SAFETY DIRECTIVE

Check of throttle control guides Model G-3/600

Issue number: SD G3-1-2005

Subject: Check of the throttle control cable guides

Figure 1-1

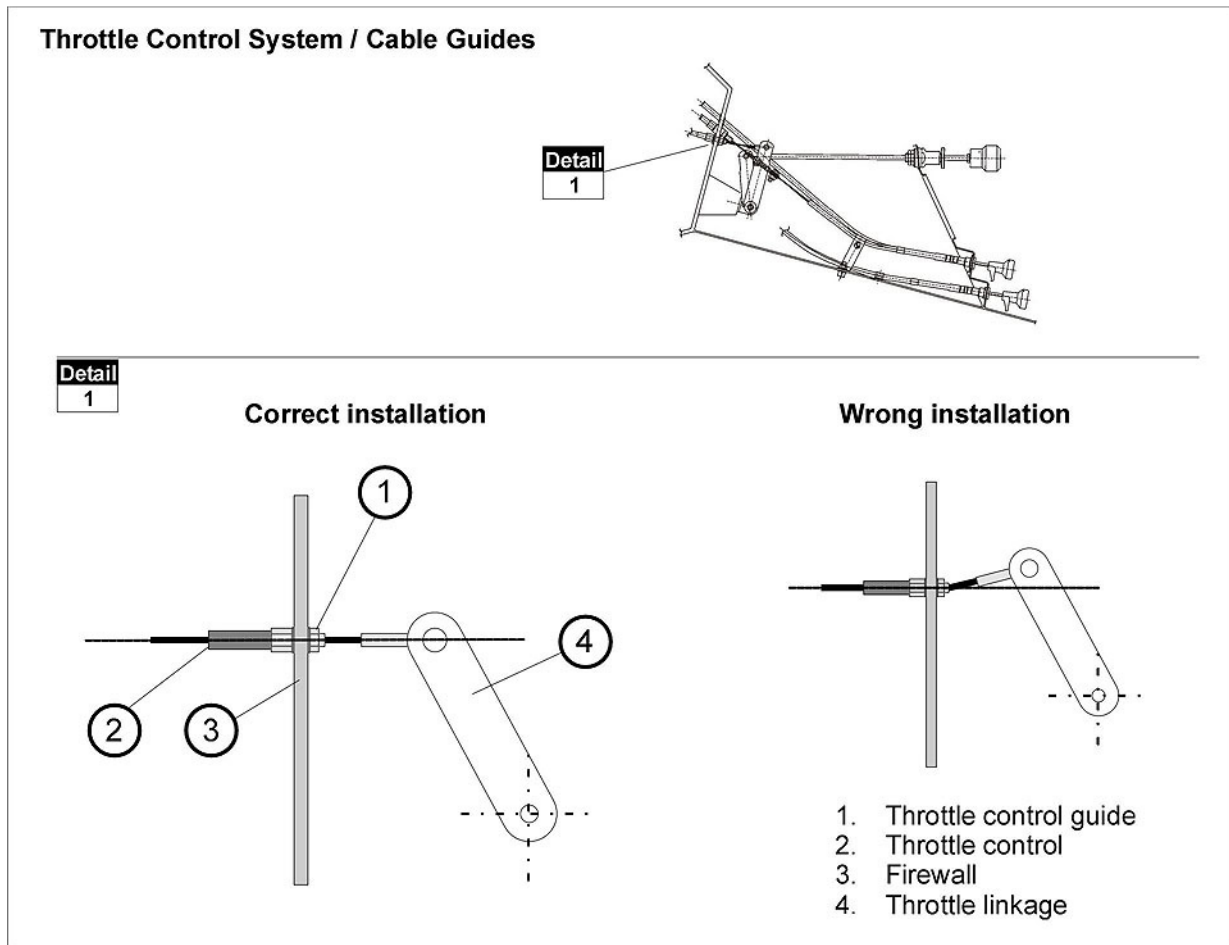
Reason: Uncorrect fitment of throttle control cable guides

Instructions: Check location of throttle control guide as illustrated in figure 1-1 and restore to original operating configuration.

Test / Inspect: Conduct test run and rigging of throttle controls in accordance with current Maintenance Manual of the G-3/600.
